Service Bulletin

**SUBJECT: Service Update for Inventory and Customer Vehicles
Possible Windshield Water Leak
Expires with Base Warranty**

MODELS: 2013 Cadillac ATS

3468438

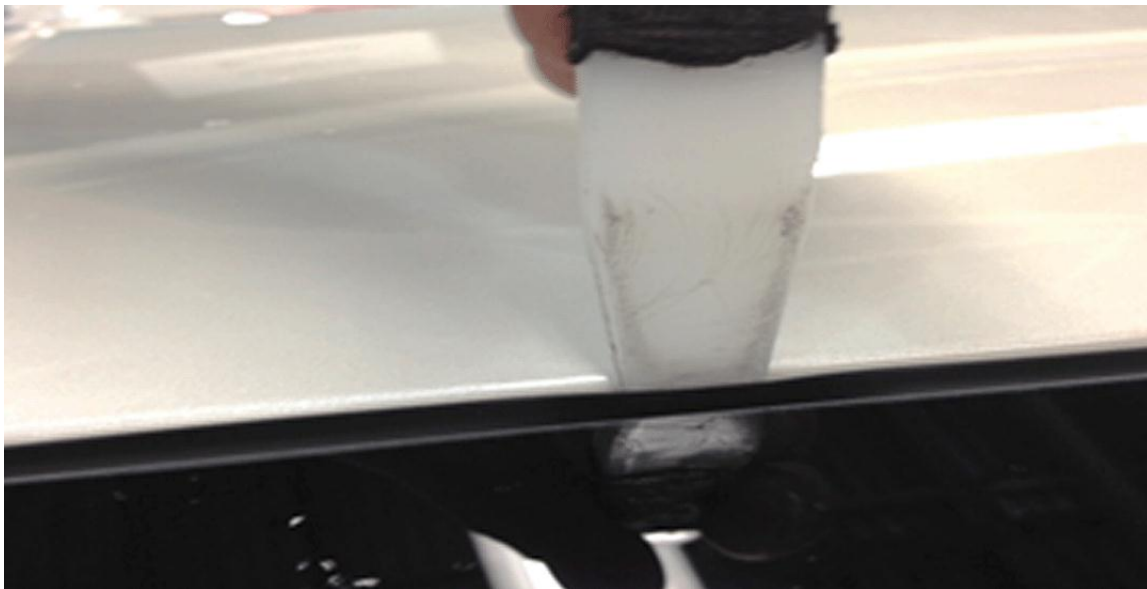
1. Perform a windshield water leak test on the passenger side of the windshield in the A-pillar area of the windshield using a water hose without the nozzle attached. Refer to photograph to view where to apply water (1).

3468441

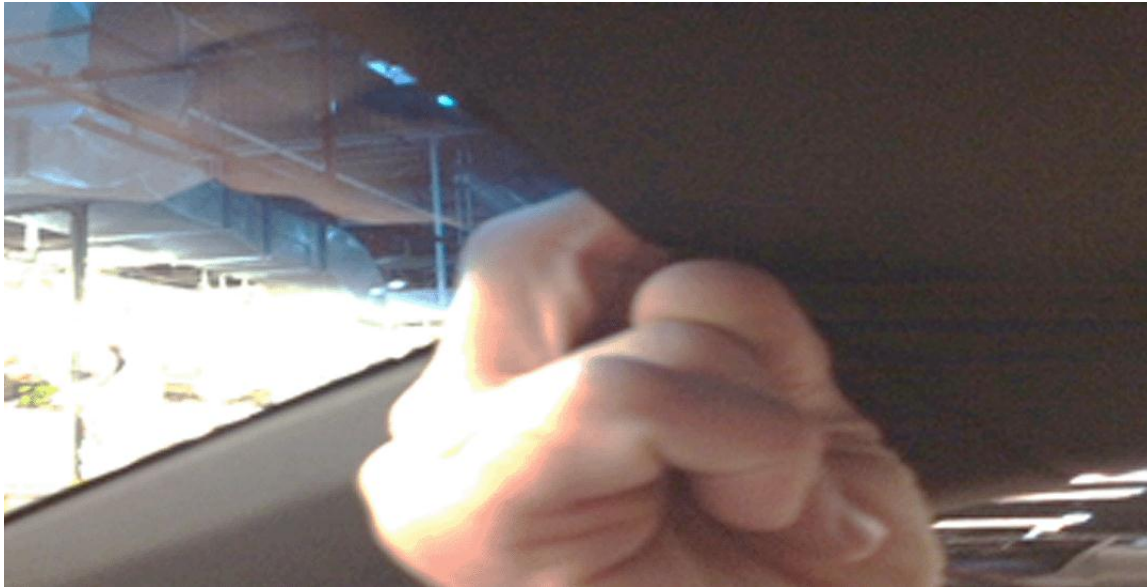
- 1.1 Using a trim stick start at the passenger side top corner of the windshield lace and gently run under the lace with the trim stick to separate it from windshield.

Note: Flow water into the access opening created by the trim stick in the test area of the windshield for 1-2 minutes.

1.2 Flow water into the access opening created by the trim stick until it flows over windshield.
